PUBLIC INTEREST REVIEW FOR GROUNDWATER APPLICATIONS

TO: Water Rights Section Date 05/04/2016
 FROM: Groundwater Section Phillip I. Marcy
 SUBJECT: Application G- 18211 Reviewer's Name
 Supersedes review of _____ Date of Review(s) _____

A. GENERAL INFORMATION: Applicant's Name: Tom and Fawn Kerns County: Baker

Water-Level Trends in Nearby Wells

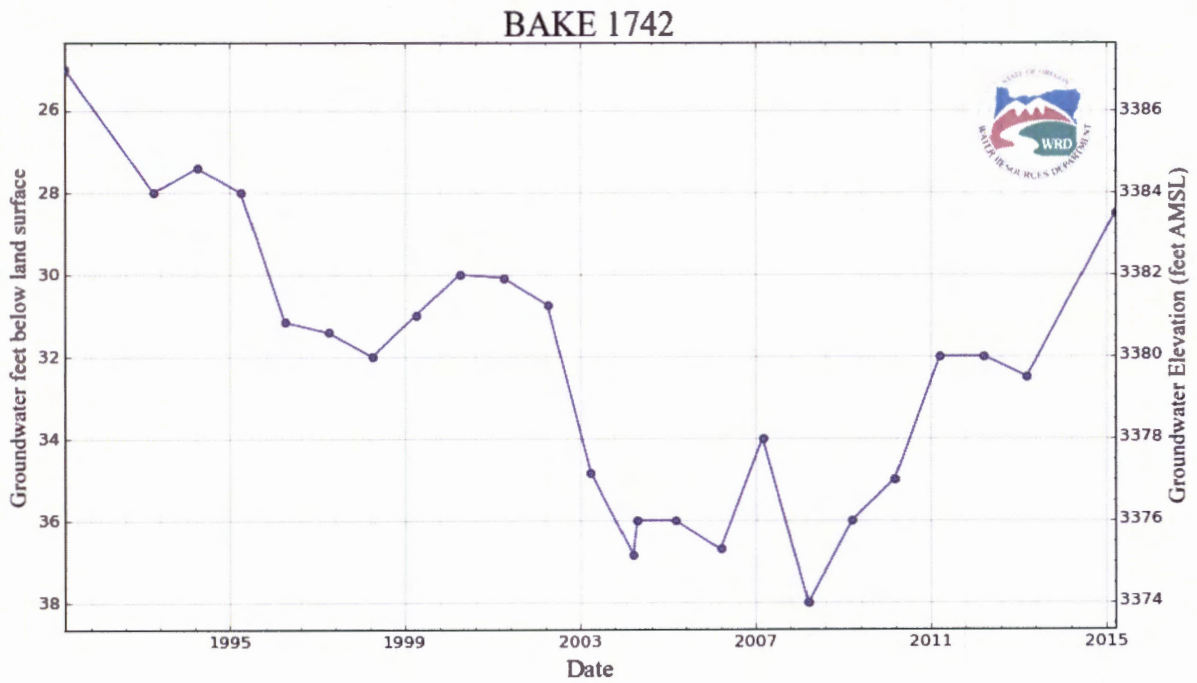
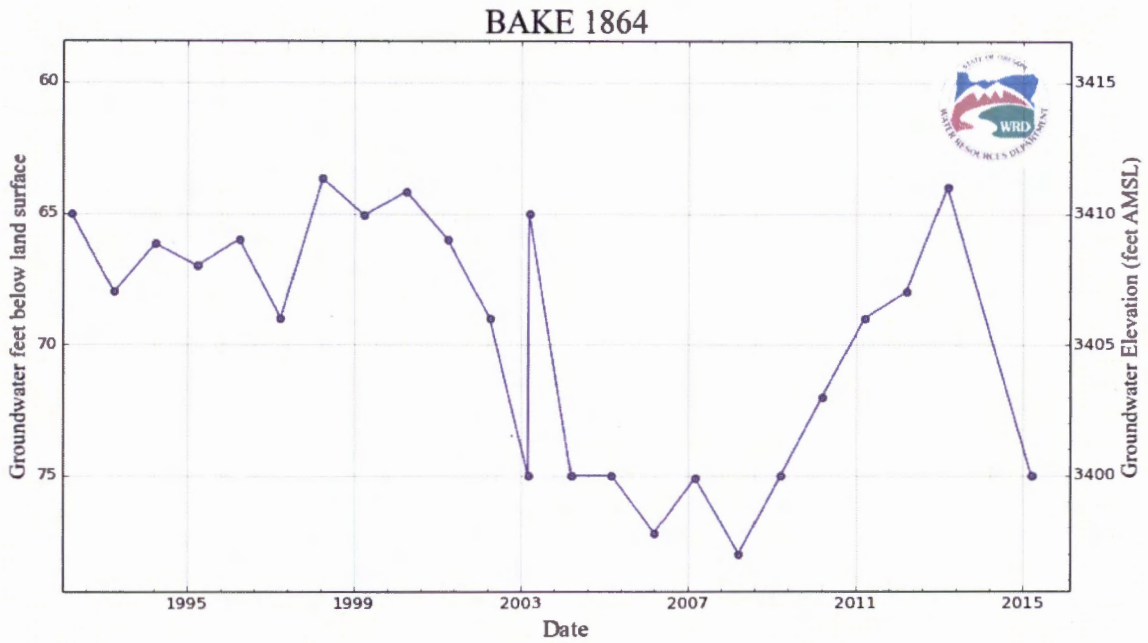
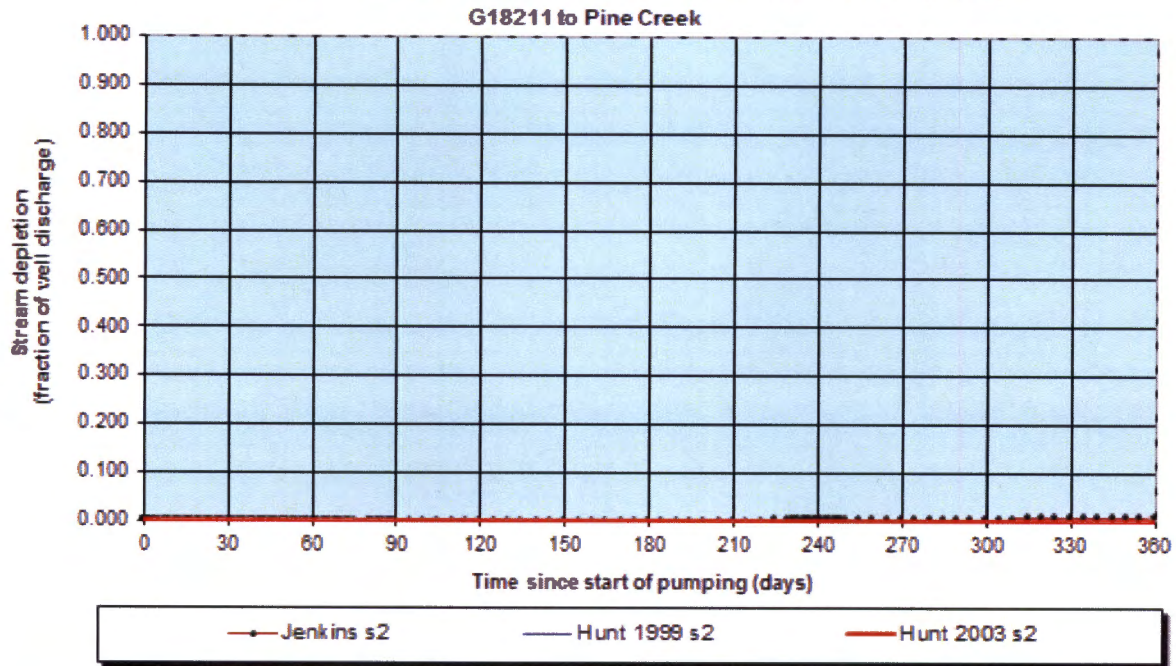
B3. **Groundwater availability remarks:** Wells are unlikely to yield the proposed rate, even if pumping is distributed between the two proposed POAs. Wells in the area producing from alluvium rarely yield greater than 100 GPM, with the highest reported yield at 600 GPM from a well drilled to a depth of 485 feet (BAKE 51383). From the available data, local groundwater levels in the alluvial aquifer appear fairly stable over the past two decades (see attached hydrographs). BAKE 1864 is located less than one mile northeast of proposed POA 2, and shows a ten foot decline between 2013-2015, but is not at historical lows reached in 2008.

Transient Stream Depletion (Jenkins, 1970; Hunt, 1999, 2003)

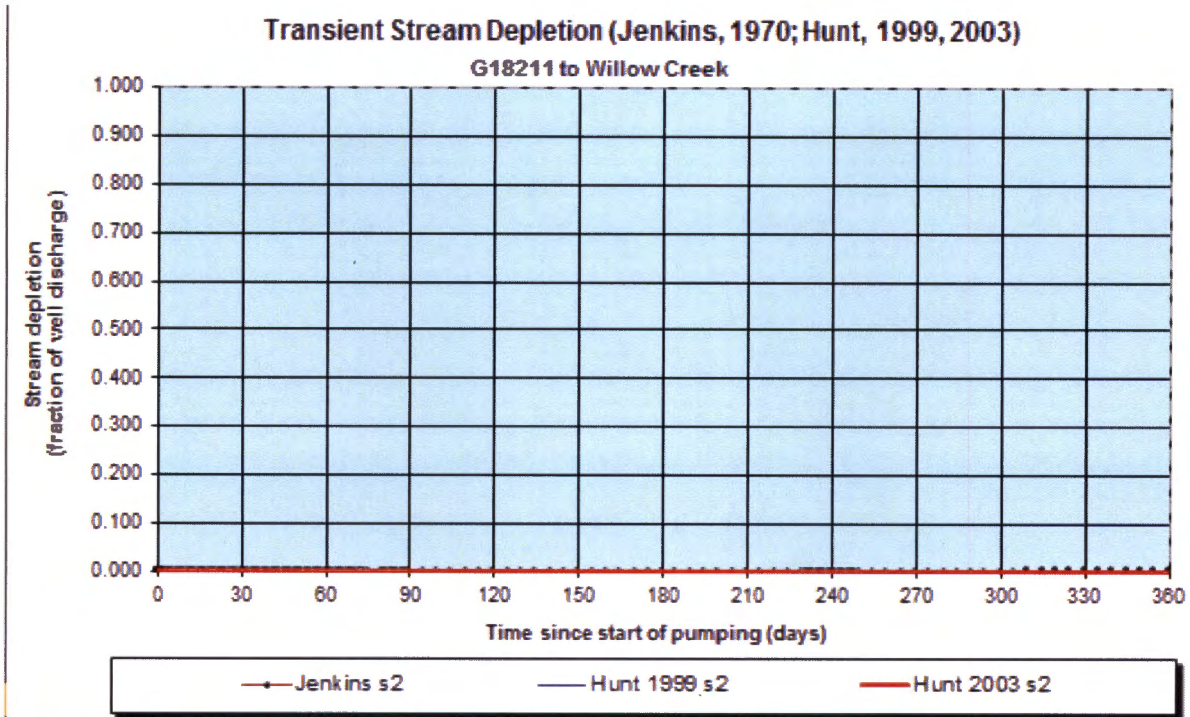
Basis for impact evaluation: The model of Hunt(2003) was utilized to model the impacts to surface water resulting from pumping at the proposed POA locations, using aquifer properties derived from local pump tests and well logs. Effects are expected to be minimal at both Willow Creek and Pine Creek due to distance from the POA locations, low hydraulic conductivity values, and relatively high storativity (estimated at 0.01) values in the unconfined alluvial aquifer.
